BELFORD AVENUE OVER HAPPY CANYON CREEK  
72'30"00" SKEW (TO LAYOUT LINE)  
74'-0" ROADWAY WIDTH, EDGE OF SIDEWALK  
TO EDGE OF SIDEWALK (ULTIMATE)  
8'-6" SIDEWALKS

Print Date: 11/18/2016 8:09:49 AM	Sheet Revisions				As Constructed	BELFORD-HAPPY CANYON CREEK BRIDGE		Project No./Code
File Name: B115360-01INF01.dwg	Date	Comments	Initials		No Revisions:	GENERAL INFORMATION		
Horizontal Scale: VARIES Vertical Scale:				Revised:	Designer: J. LYNCH	Structure Numbers		
				Void:	Detailer: C. MIYAMOTO			
6300 South Syracuse Way, Suite 600 Centennial, CO 80111 tel 303.721.1440 fax 303.721.0832					Subset: BRIDGE	Sheets: B1 of 32		Sheet Number 11

**BELFORD-HAPPY CANYON CREEK BRIDGE**  
**SUMMARY OF QUANTITIES**

As Constructed	BELFORD-HAPPY CANYON CREEK BRIDGE		Project No./Code
No Revisions:	PIER 2		
Revised:	Designer: J. LYNCH	Structure Numbers	Sheet Number 27
Void:	Detailer: R. DILLON	Sheets: B17 of 32	
	Subset: BRIDGE

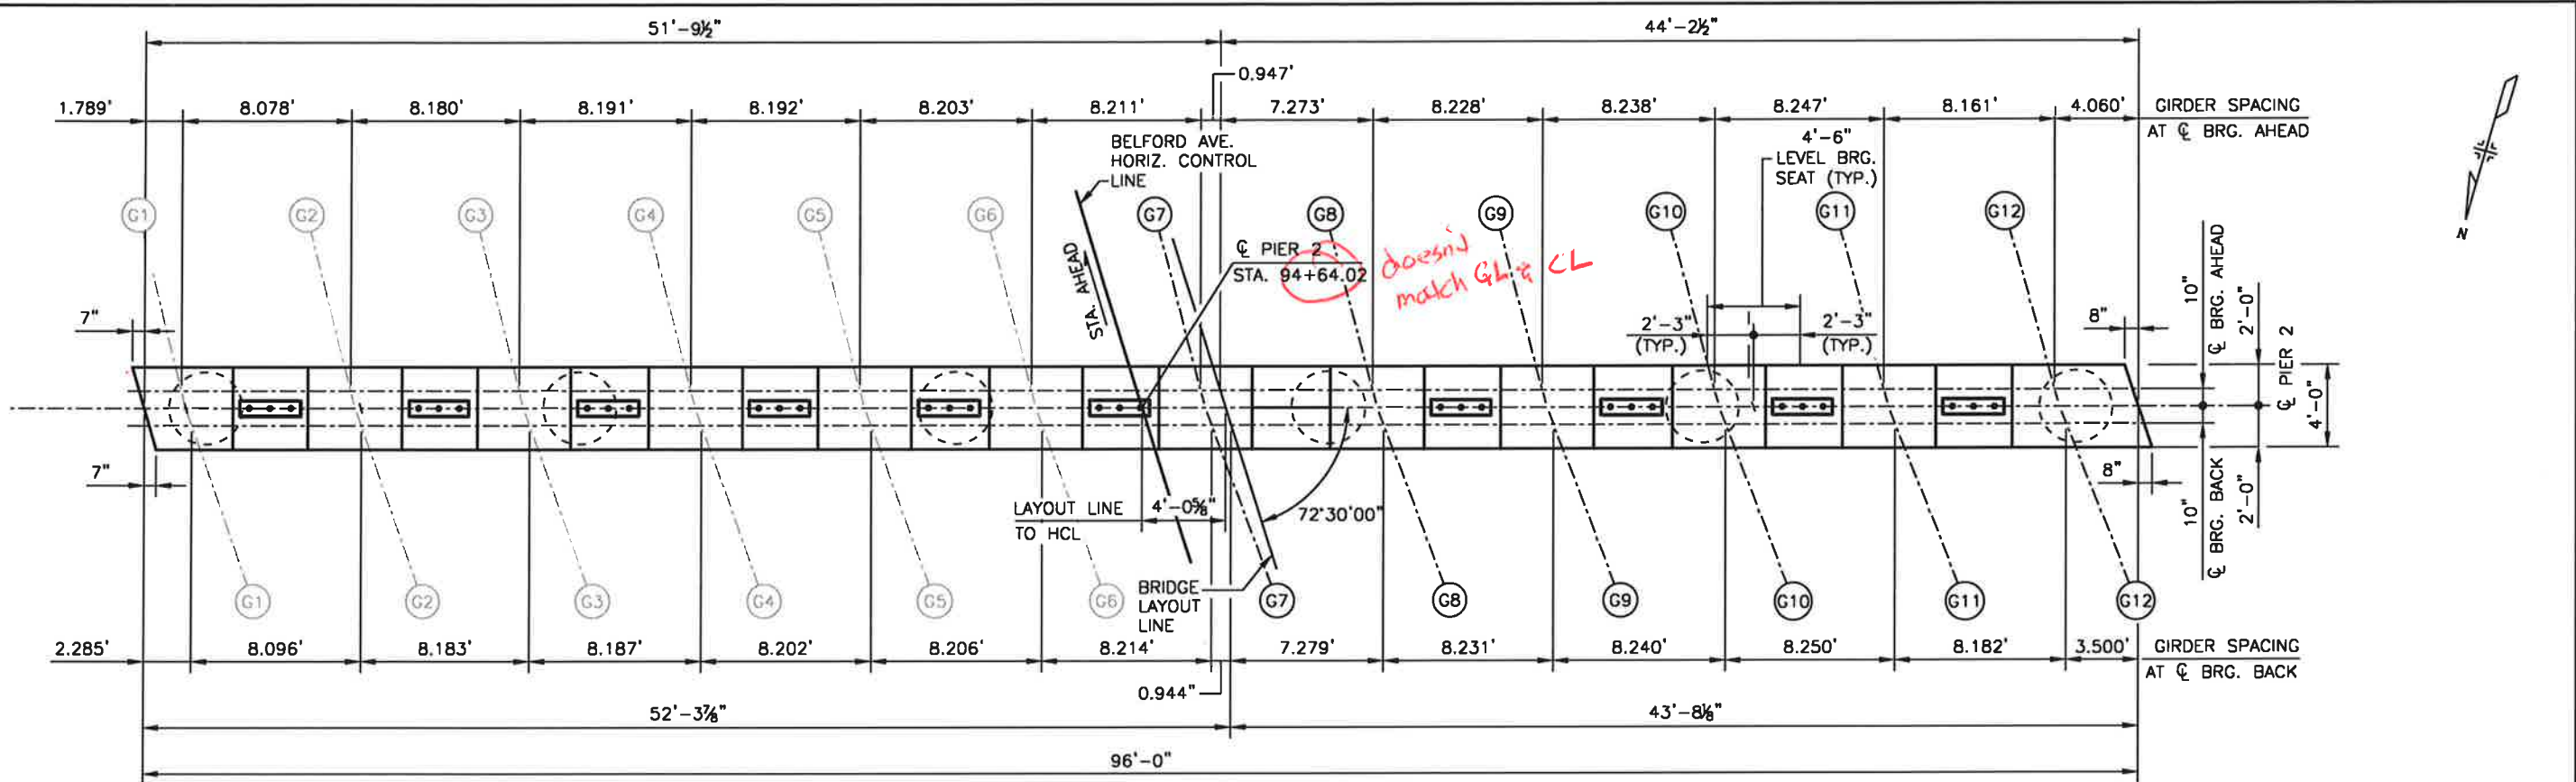
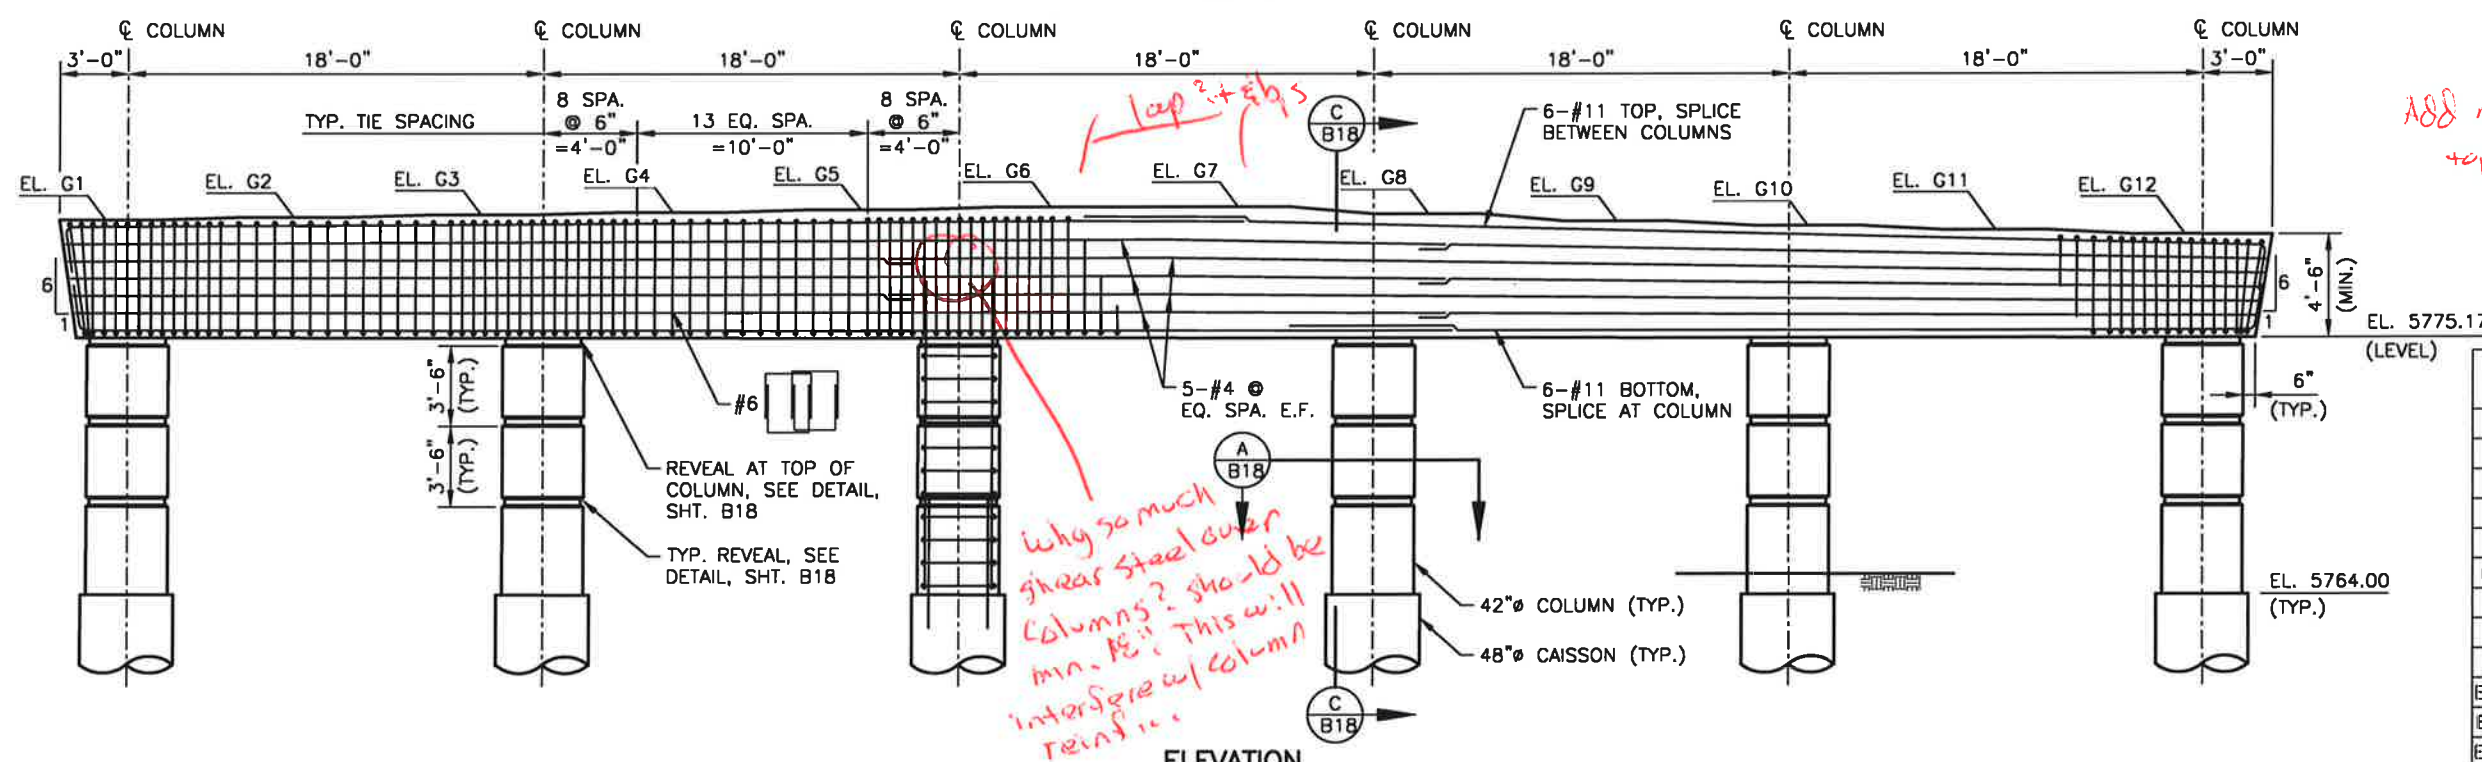
*Arg*  
Add note - elevation of top of concrete.

As Constructed	BELFORD-HAPPY CANYON CREEK BRIDGE PIER SECTIONS & DETAILS		Project No./Code
No Revisions:	Designer: P. STEIN	Structure Numbers	
Revised:	Detailer: DILLON/MIYAMOTO		
Void:	Subset: BRIDGE	Sheets: B18 of 32	Sheet Number 28

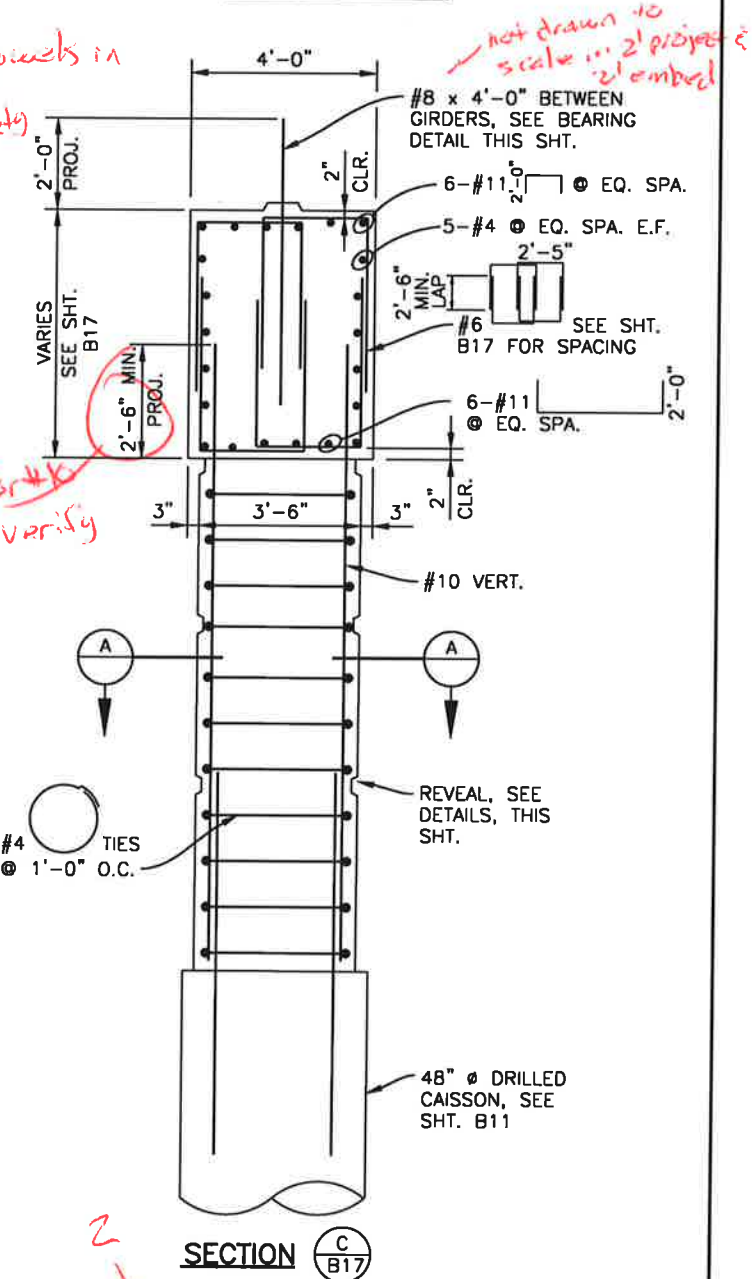
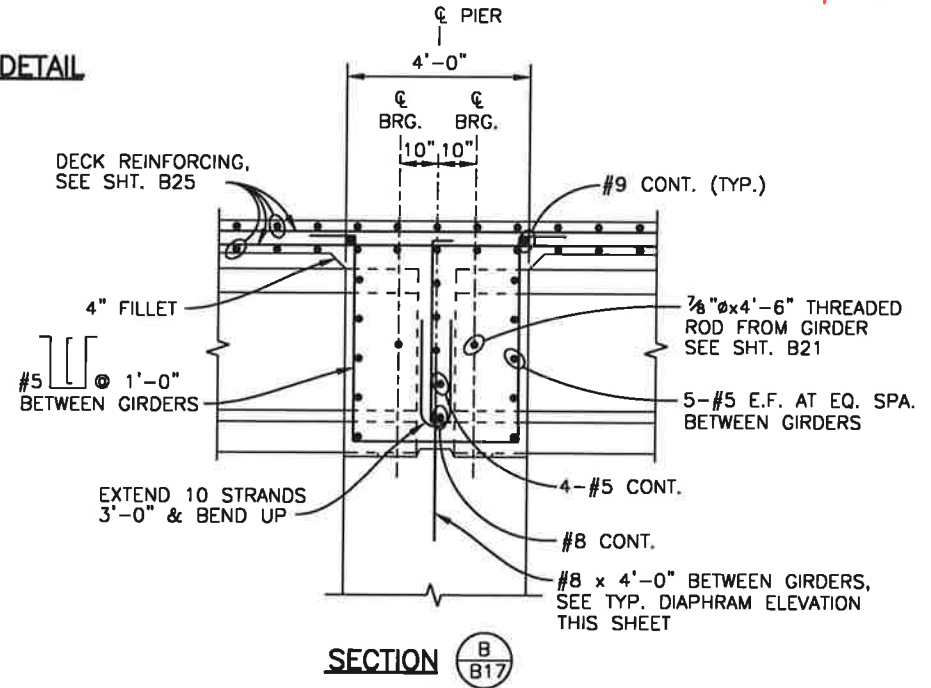
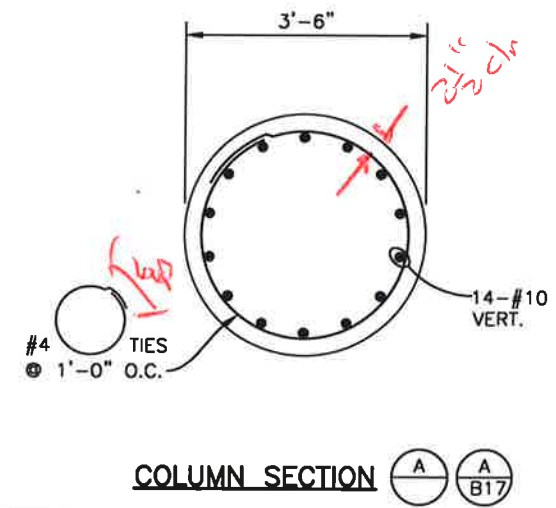
Are you installing #8 dowels in future? Aesthetic/Safety issue? Drill spacing?

seems small for epoxy barrier verify

TYPICAL INTERIM SECTION  
(LOOKING SOUTH)

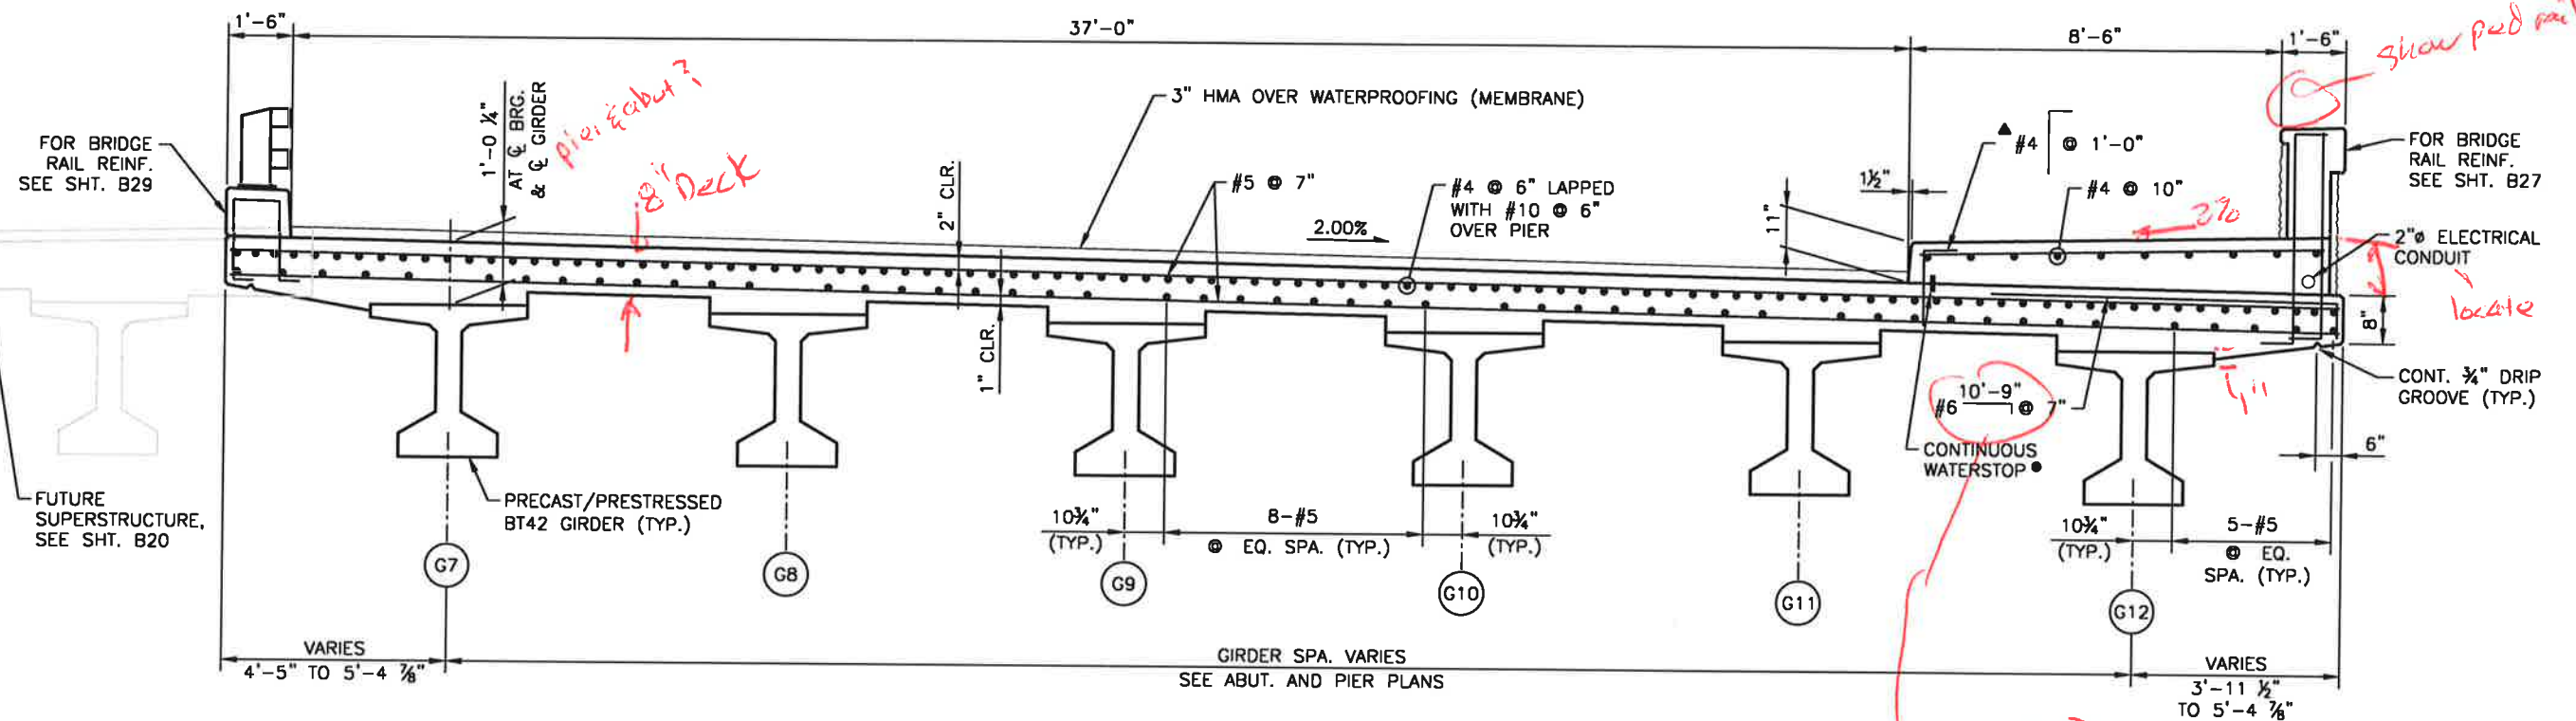
*This ok to do where  
applying veneer???*

TYPICAL FUTURE SECTION  
(LOOKING SOUTH)

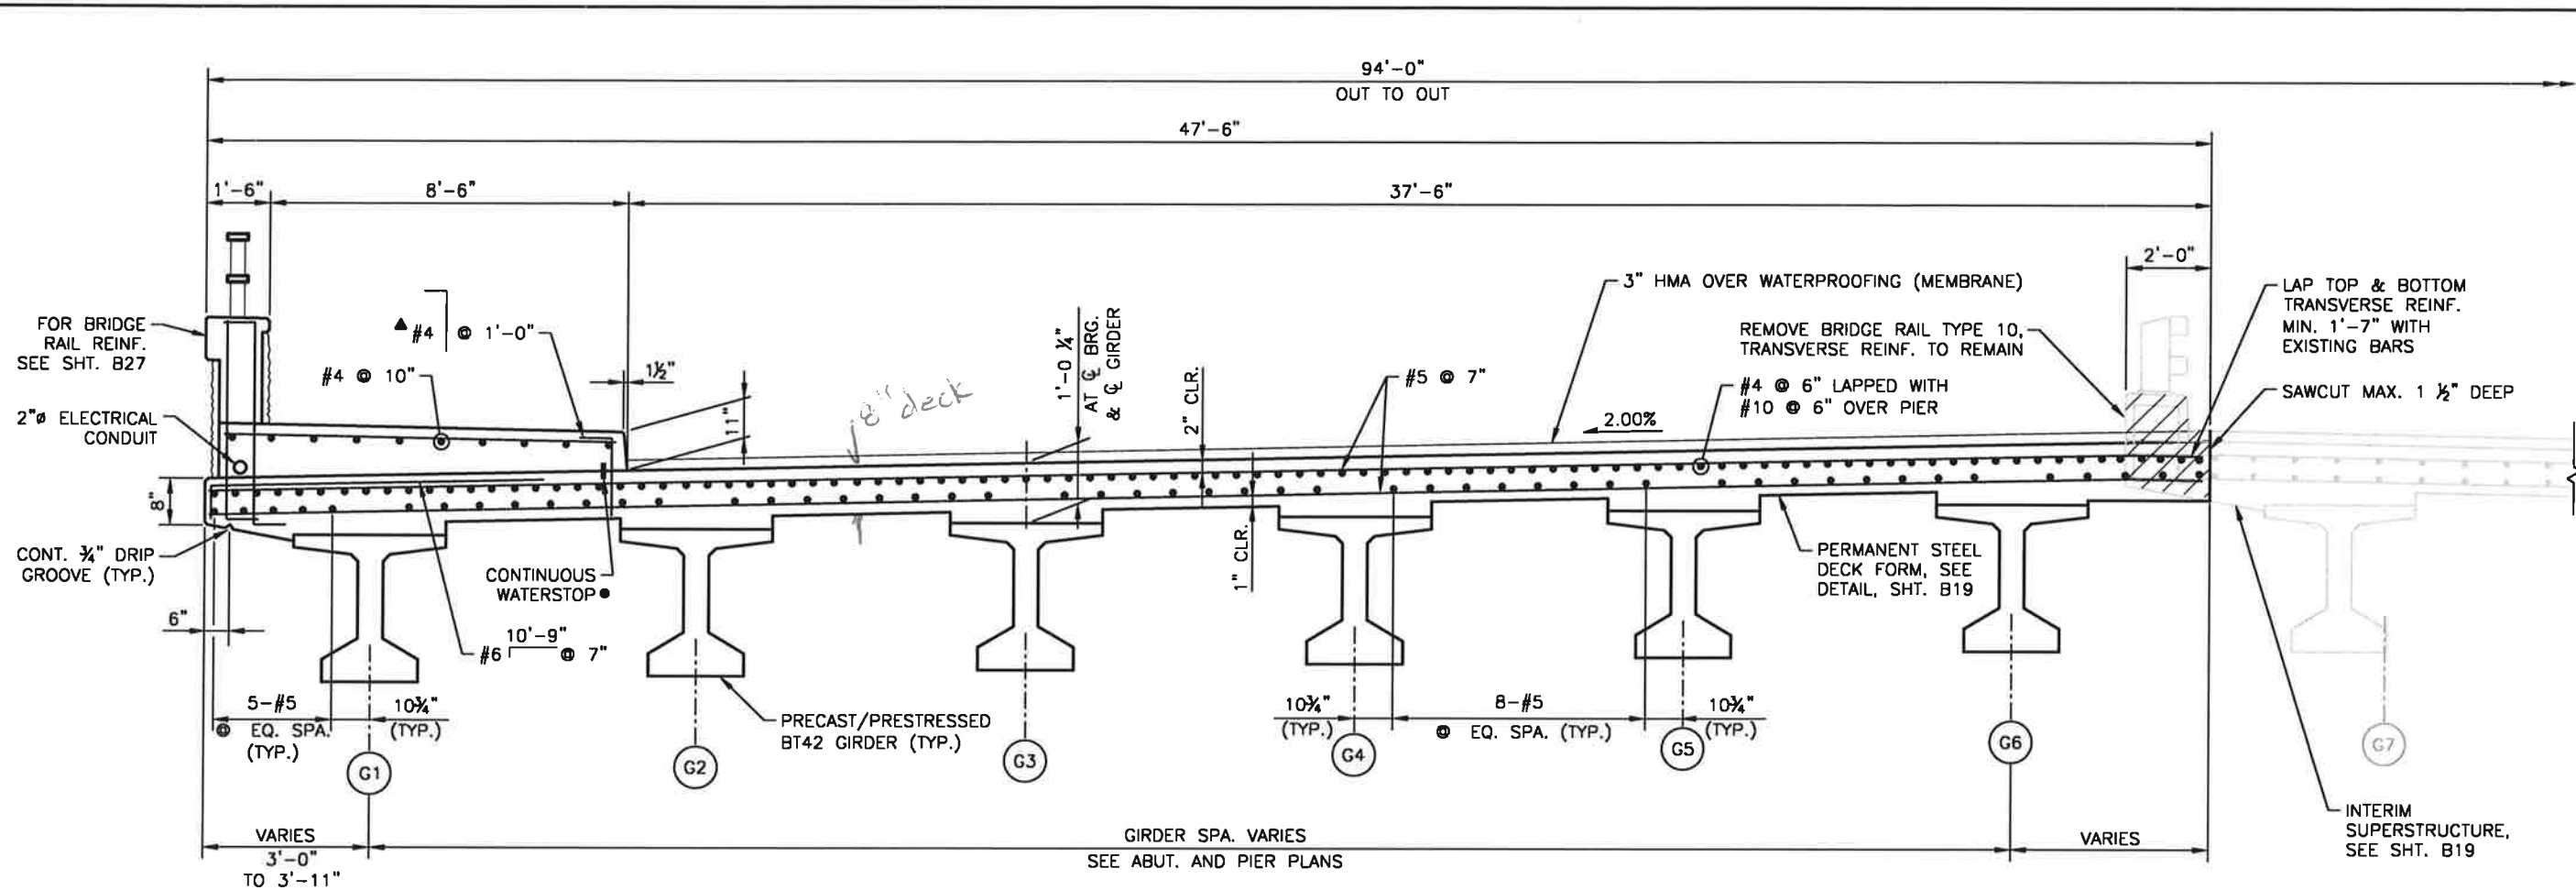
*Same comments as interim*
